***Interactive comment on “Water balance modelling  
in a semi-arid environment with limited in-situ  
data: remote sensing coupled with satellite  
gravimetry, Lake Manyara, East African Rift,  
Tanzania” by D. Deus et al.***

General reply to Reviewer 1-C4854-2011

Figure 1: Model result based on (a) MODIS LST and (b) in-situ air temperature

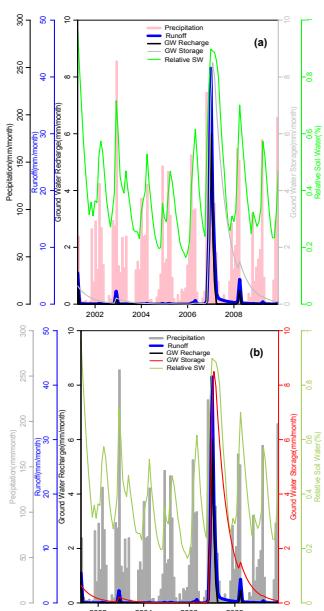
As it is explained in the paper, MODIS LST product is used as model input. This means that evapotranspiration is also calculated using LST data. However, the Penman-Montheith method for ET estimation uses air temperature as an input. This is why the authors should clarify how LST was integrated into the model. Was it directly used constituting air temperature information, which is actually not correct?

We agree that Penman\_Montheith method for ET estimation use air temperature as input. Nonetheless we showed that LST and air temperature are correlated and therefore we can estimate air temperature from LST. In order to check the effect of using LST we used both air temperature and MODIS LST to force two separate models. The results produced using MODIS LST and in-situ air temperature are very similar and we conclude that air temperature estimated from LST is a valid temperature input (Fig. 1a,b). We have edited the text to make these points clearer.
